Petition No. 1221  
Interrogatories  
Set One  
April 14, 2016

Windham Solar LLC (WS) Responses April 28, 2016

**PLAINFIELD PIKE SOLAR**  
 91 PLAINFIELD PIKE RD  
 PLAINFIELD, CT 06374  
 WINDHAM COUNTY

# AQUIFER PROTECTION AREAS

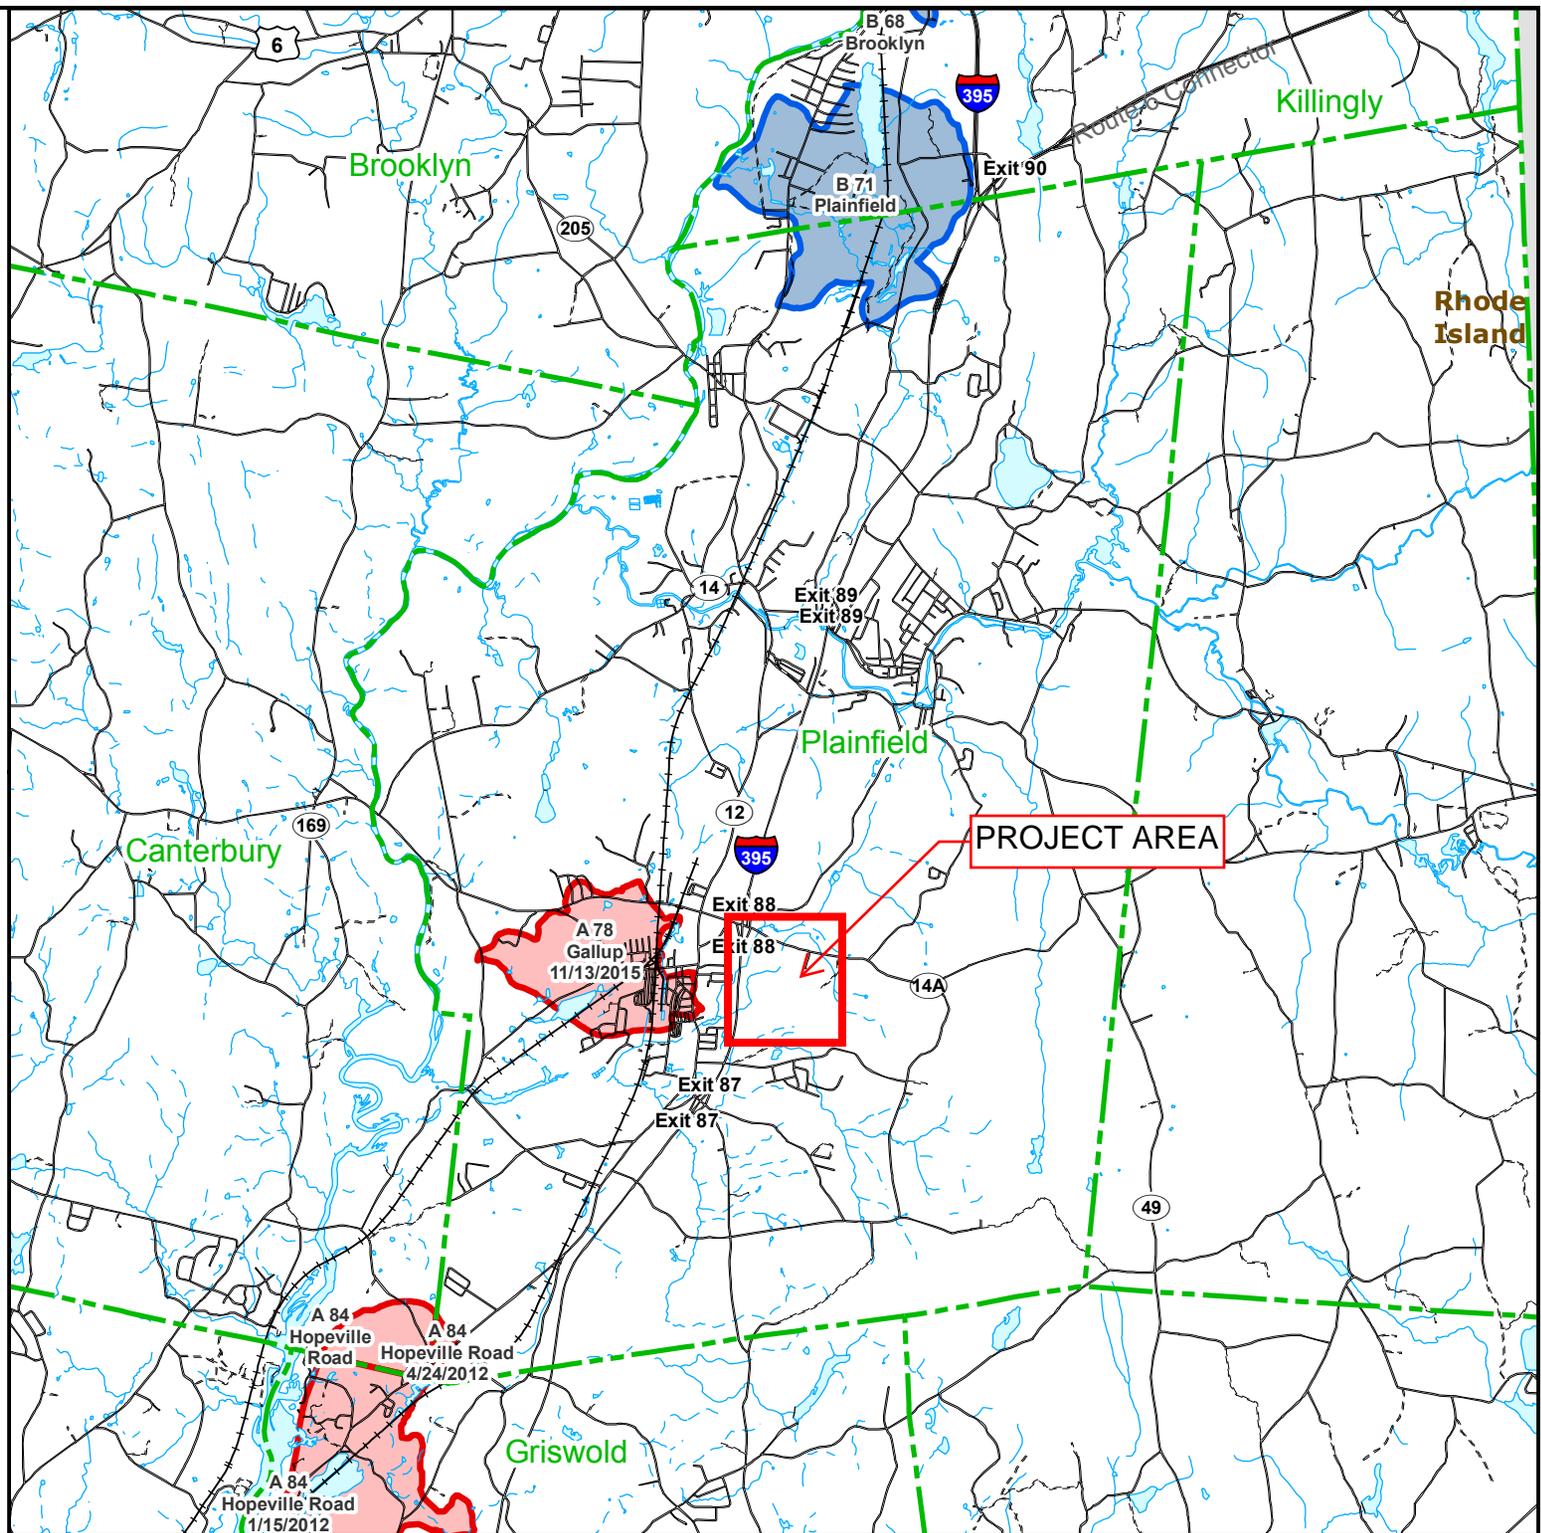
27. Is the proposed project located within an aquifer protection area?

No, an aquifer protection map has been attached. - Exhibit F
